Mini Holland Cycle Scheme

Stage 1 Road Safety Audit

Ref: 2524/032/A105/BOR/2016

London Borough of Enfield

FILE: PROPOSED A105 ROUTE SHEET 1	
SCALE: NTS	DRAWING NO: B240G001-SK-A105-001-01
REV: E

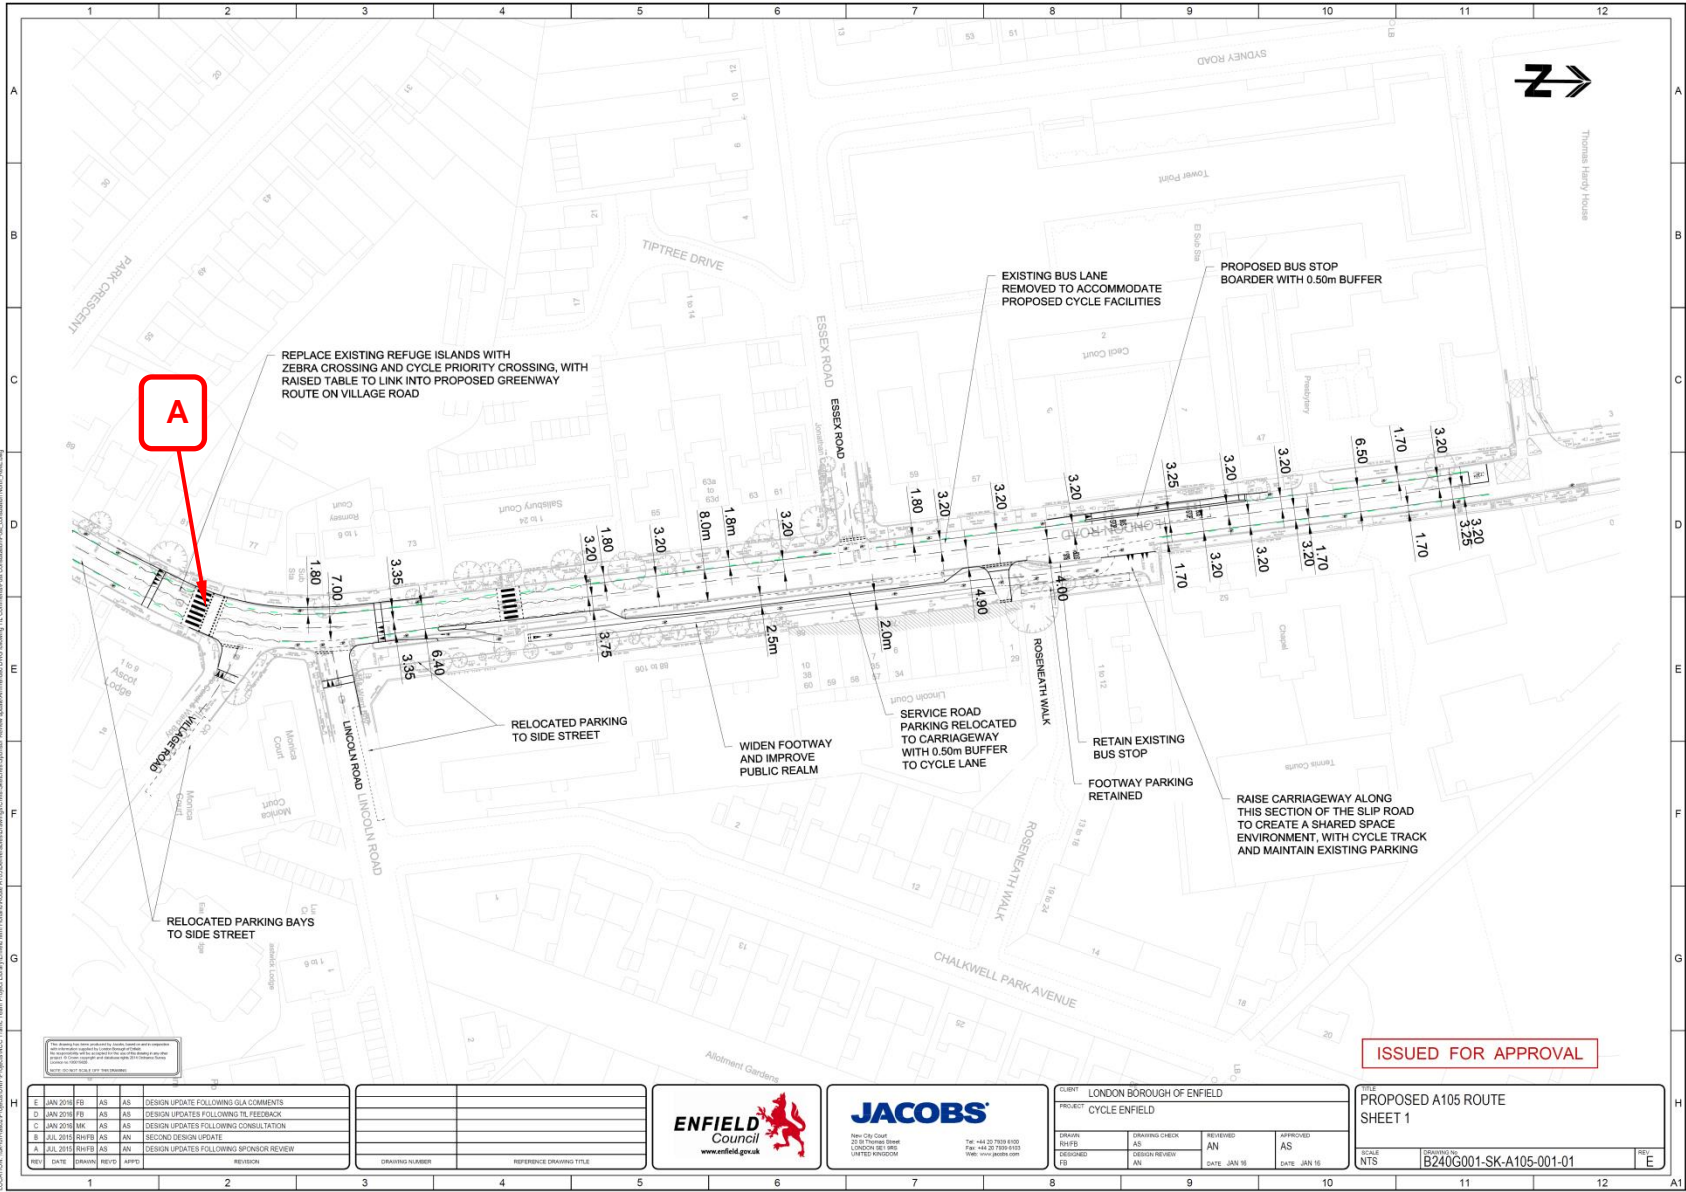
3.2 DRAWING 001-01

Location: A - Zebra crossing near Village Road

Summary: Narrow footways may bring cyclists and pedestrians into conflict

The footways in the vicinity of the zebra crossing are relatively narrow and may not safely accommodate pedestrians and cyclists at the crossing area. This may lead to pedestrian to cycle collisions.

The footway areas should be widened to accommodate both user types. Cycle routes through the crossing area should be clarified.

Design Organisation Response	Part Accepted
<p>It is accepted that footways are constrained in this location which is why the corner between Village Road and Green Lanes, outside Ascot Lodge has been tightened. However no further widening of the footway is recommended as carriageway widths are already constrained on the bend, with traffic lanes at 3.25m wide and the cycle lane at approximately 1.70m wide at the crossing location. Pedestrian volumes are low at this location and therefore it is felt that the benefits from widening the footway further would be small for pedestrians but the dis-benefits to motor traffic and cyclists' safety would be significant. The crossing provides a safe movement for nervous cyclists travelling to and from the greenway cycle routes.</p>	
<h4>Client Organisation Comments</h4> <p>Designer's response accepted</p>

FILE	PROPOSED A105 ROUTE SHEET 2	
SCALE	DRAWING No.	REV
1:1	B240G001-SK-A105-001-02	E

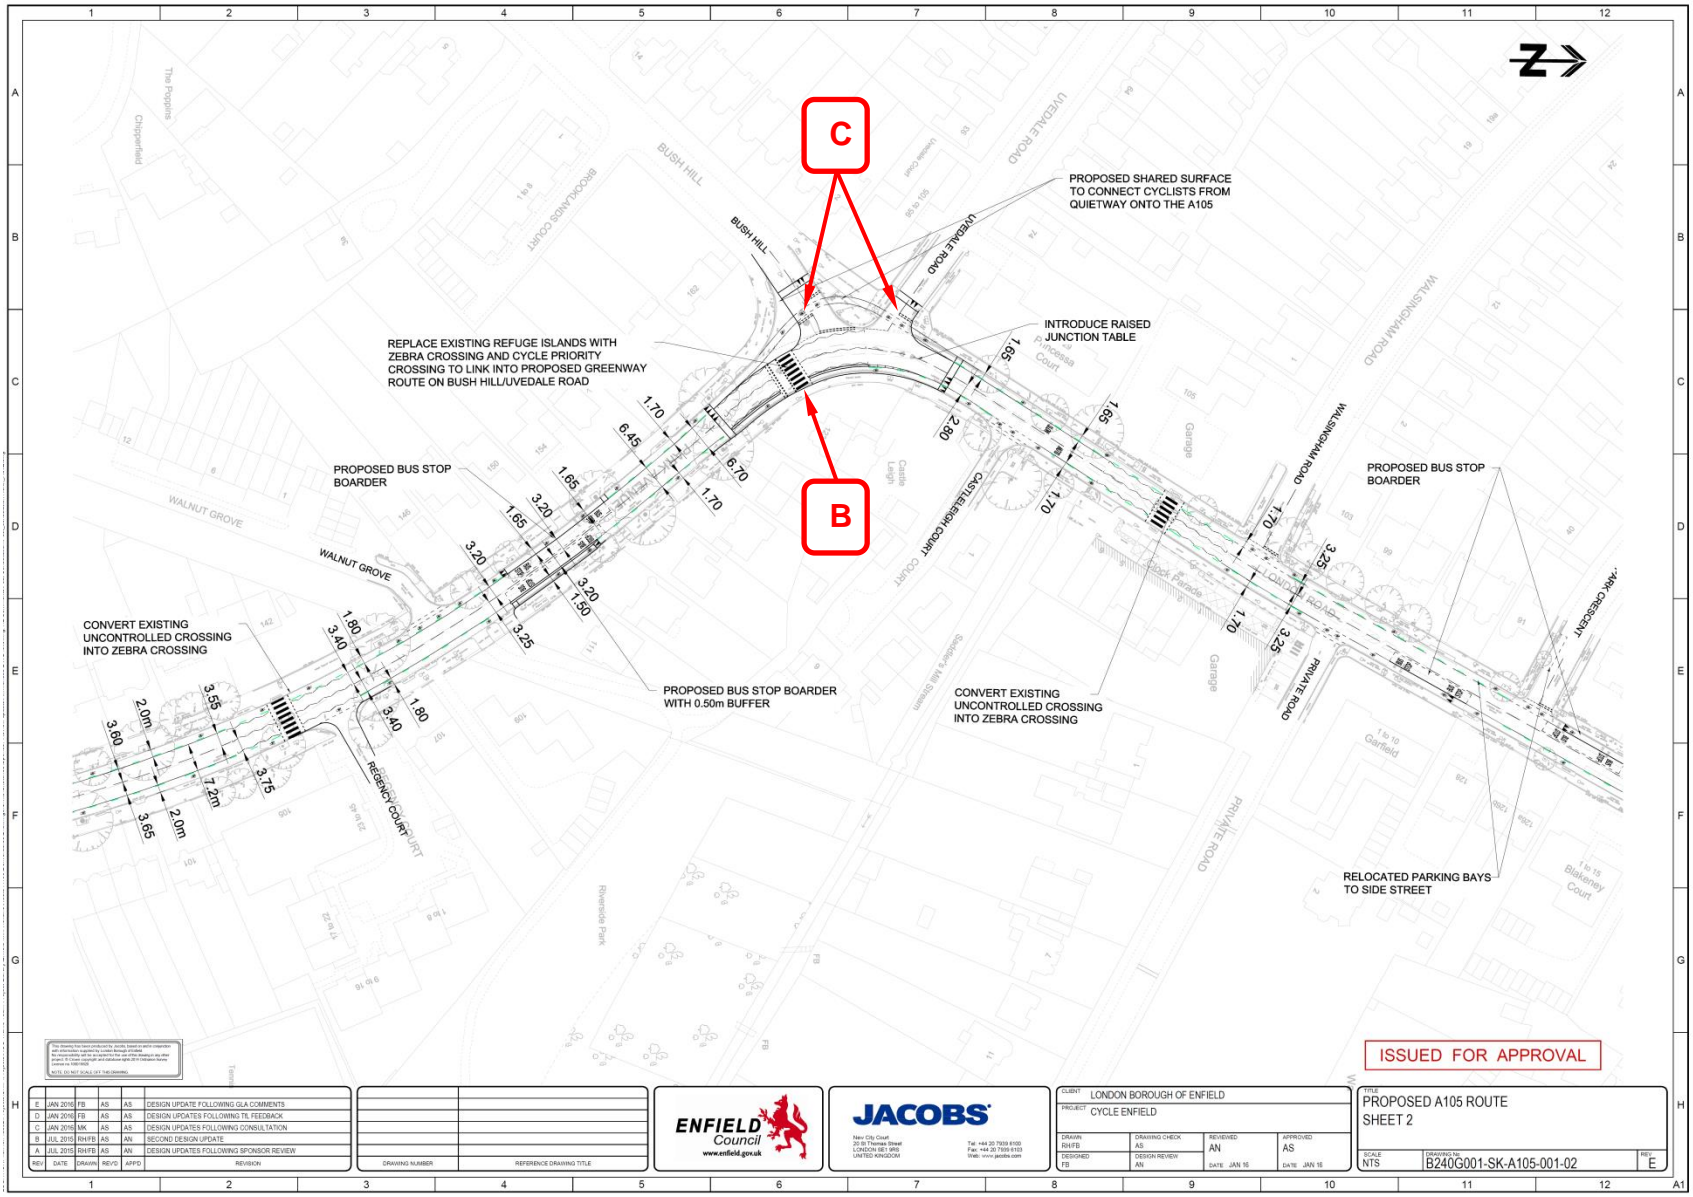
3.3 DRAWING 001-02

Location: B - At the zebra crossing near Bush Hill

Summary: Poor visibility at the bend may lead to failure to give way type collisions involving pedestrians

On the southbound approach to the crossing, drivers may have a poor view of pedestrians on the eastern footway. This may lead to drivers failing to give way at the crossing and may result in pedestrian to vehicle collisions.

It is acknowledged that the raised table will reduce vehicle speeds however adequate visibility between users should be provided at the crossing. This may require the relocation of the crossing.

Location: C - At Bush Hill and Uvedale Road

Summary: Inconsistent cycle crossing facilities may lead to late braking nose to tail or failure to give way type collisions

There are inconsistent cycle crossing facilities across these junction cycle facilities. At Bush Hill drivers entering the side road are asked to give way to cyclists, whereas at Uvedale Road there are no give way facilities. The inconsistent provision may confuse drivers and cyclists and may lead to failure to give way or late braking type collisions.

The cycle crossing provision at these junctions should be consistent with each other and consistent along the route to assist users in adequately comprehending the likely manoeuvres of users at these locations.

Design Organisation Response	Rejected
<p>The proposed visibility splay is 33.8m. Relocating the crossing to the south reduces visibility splays, and there is no scope to the north because of the junctions of Uvedale Road and Bush Hill.</p> <p>ATC data shows that the mean speed is 22.6mph and 85%ile of 25.9 at a comparable location (Green Dragons Lane to the south of Bush Hill on the A105).</p> <p>The proposed scheme reduces carriageway widths and the area is on a raised table and is therefore likely to reduce speeds, compared to existing.</p> <p>Assuming a speed of 25mph the recommended Stopping Sight Distance (SSD) is 33m, at 20mph this is 25m.</p> <p>The alternative would be to remove the crossing which is considered a negative impact on pedestrians, particularly with the closely associated bus stops to the south.</p>	
Client Organisation Comments	
Designer's response accepted

Design Organisation Response	Accepted
<p>The design has been amended so there is a consistent layout on both side arms</p>	
Client Organisation Comments	
Designer's response accepted

TITLE	PROPOSED A105 ROUTE SHEET 3
SCALE	NTS
DRAWING NO.	B240G001-SK-A105-001-03
REV.	E

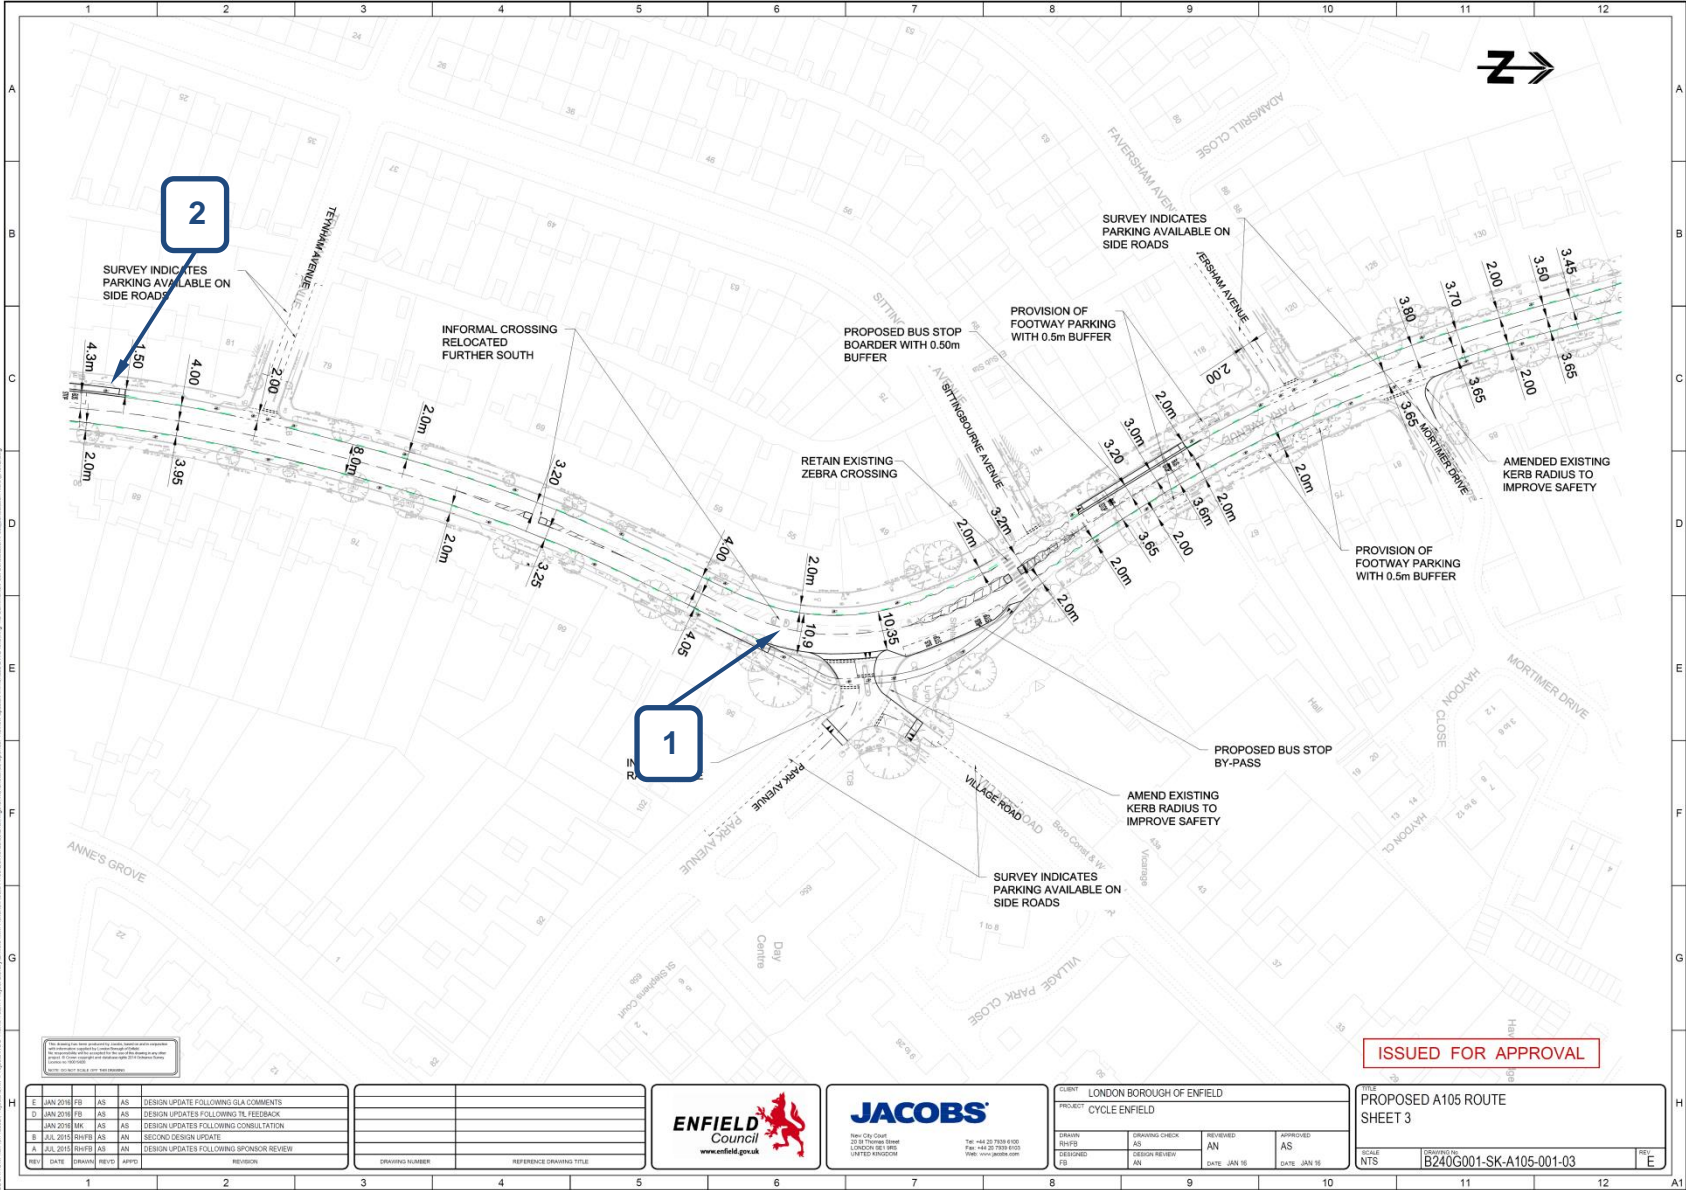
Location: 1 - Drawing 001-03 – near Park Avenue

Location: 2 - Drawing 001-03 & 04 – at the northbound bus boarder

Design Organisation Response	Rejected
<p>Pedestrian desire lines in this location around Park Avenue are served by two crossings on both sides of the A105/Park Avenue junction. There is an existing formal (zebra) crossing north of Park Avenue which is retained and an advisory crossing facility south of Park Avenue which is relocated 70m south of the existing one. The reason for this relocation was to provide adequate traffic lane and cycle lane widths around the horizontal curve on the A105 in this location. The desire lines are still safely accommodated by these two crossing facilities proposed. The only pedestrian movements that will be negatively impacted by the relocation of the informal crossing will be pedestrian movements between Park Avenue and the properties between the existing pedestrian refuge and the proposed one (property numbers 53-67).</p>

Design Organisation Response	Part Accepted
<p>The proposed bus stop is retained in the existing bus stop location. The driveways of 87/89 and 93 are within the bus stop cage, as existing. In the designs we propose a bus stop boarder 1.50m wide with an additional 0.50m buffer strip for extra safety. Dropped kerbs will be provided to these properties within the 0.50m buffer strip. This will be addressed in the detailed design stage where levels and kerb heights will be looked at in detail.</p>	
Client Organisation Comments	
<p>Designer's response accepted.</p>

PROPOSED A105 ROUTE SHEET 4	
SCALE: NTS	PROJECT NUMBER: B240G001-SK-A105-001-04

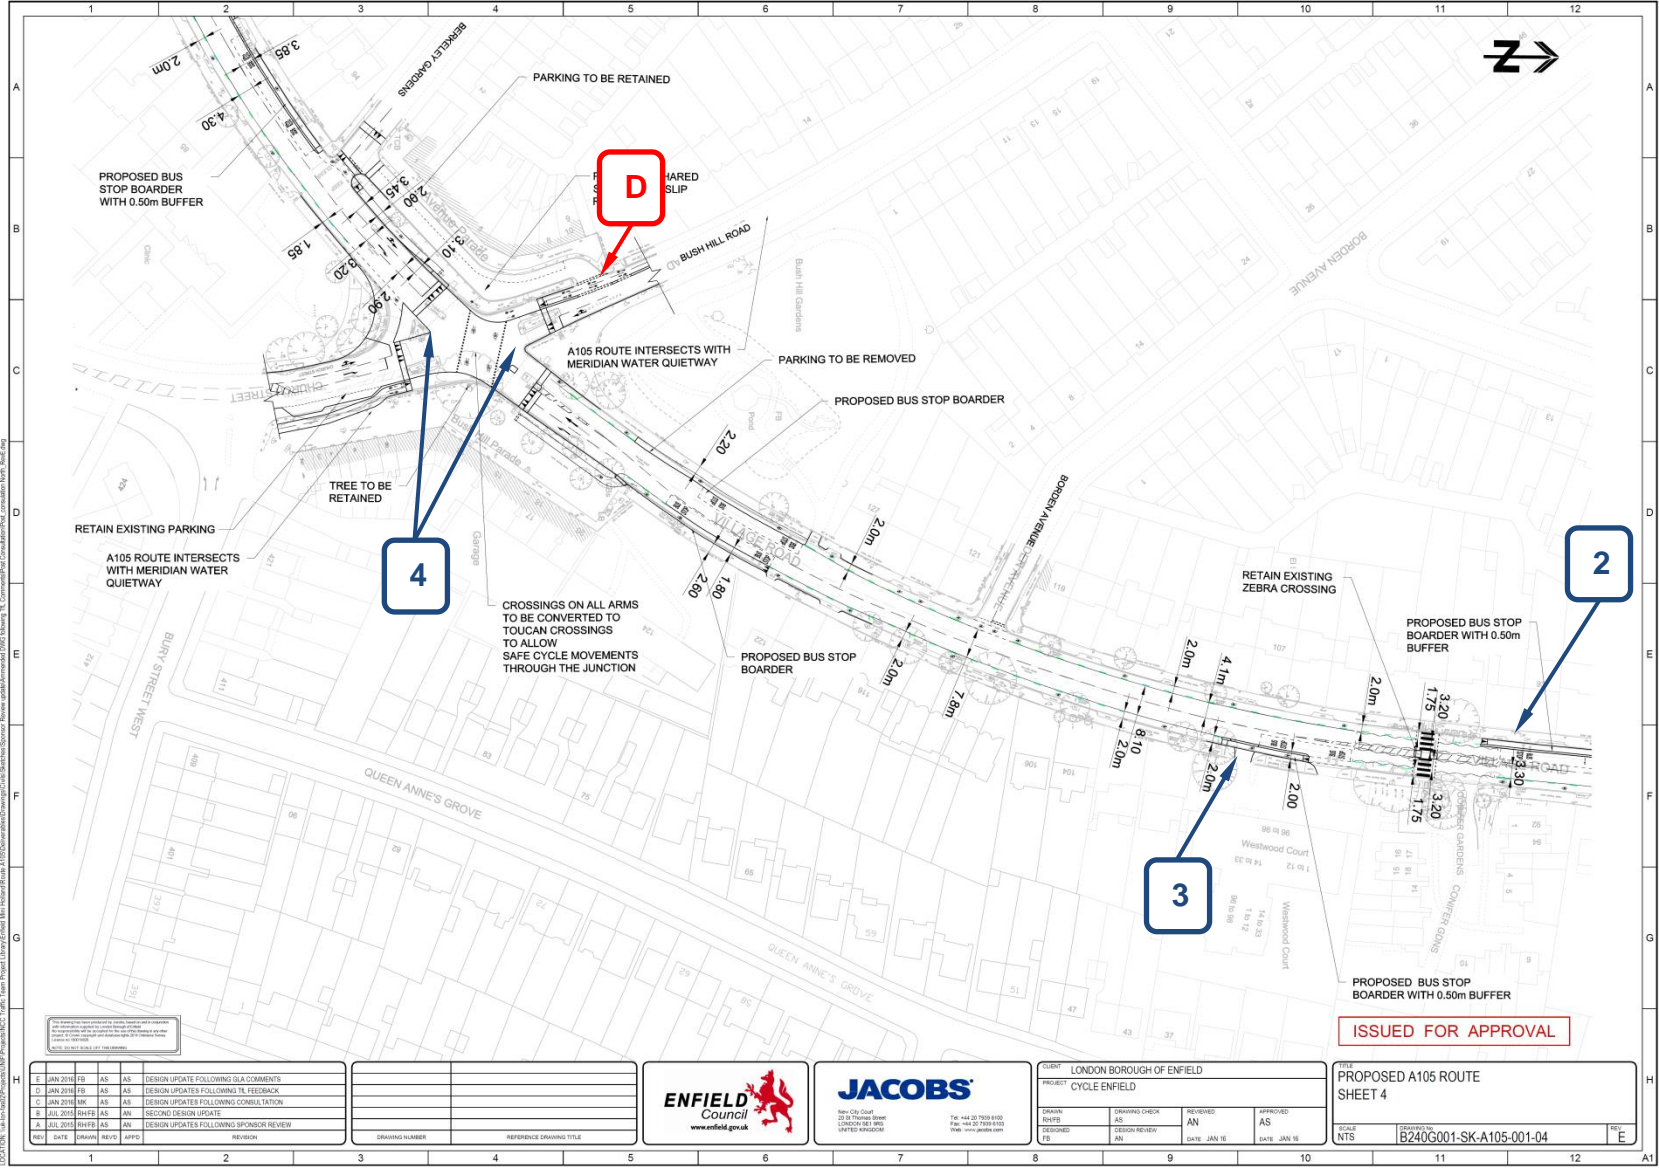
3.4 DRAWING 001-04

Location: D - Bush Hill Road – Avenue Parade access

Summary: Two-way cycle lane past side road access may increase the potential for turning collisions involving cyclists

The two-way cycle lane past the shopping parade access is likely to increase the complexity of decision making for drivers making turns to or from the access. Poor turning manoeuvres are likely to increase the likelihood of collisions involving cyclists at this location.

Location: 3 - Drawing 001-04 – at the southbound bus boarder outside Westwood Court

Design Organisation Response	Part Accepted
<p>Under the proposed designs the service road (Avenue Parade) would become one-way north-eastbound, so vehicles from Bush Hill Road cannot turn directly onto Avenue Parade. This simplifies the turning manoeuvres from Avenue Parade to Bush Hill Road compared to the existing situation. The cycle track on Bush Hill Road will be raised to give cyclists priority across the access, as recommended.</p> <p>There is not scope to provide a one-way segregated cycle track on Bush Hill Road and Church Street due to constraints on carriageway widths.</p>	
Client Organisation Comments	
<p>Designer's response accepted</p>

Design Organisation Response	Part Accepted
<p>As with Issue 4.4, the proposed bus stop is retained in the existing bus stop location, with driveways within the bus stop cage, as existing. In the designs we propose a bus stop boarder 1.50m wide with an additional 0.50m buffer strip for extra safety. Dropped kerbs will be provided to these properties within the 0.50m buffer strip. This will be addressed in the detailed design stage where levels and kerb heights will be looked at in detail.</p>	
Client Organisation Comments	
<p>Designer's response accepted.</p>
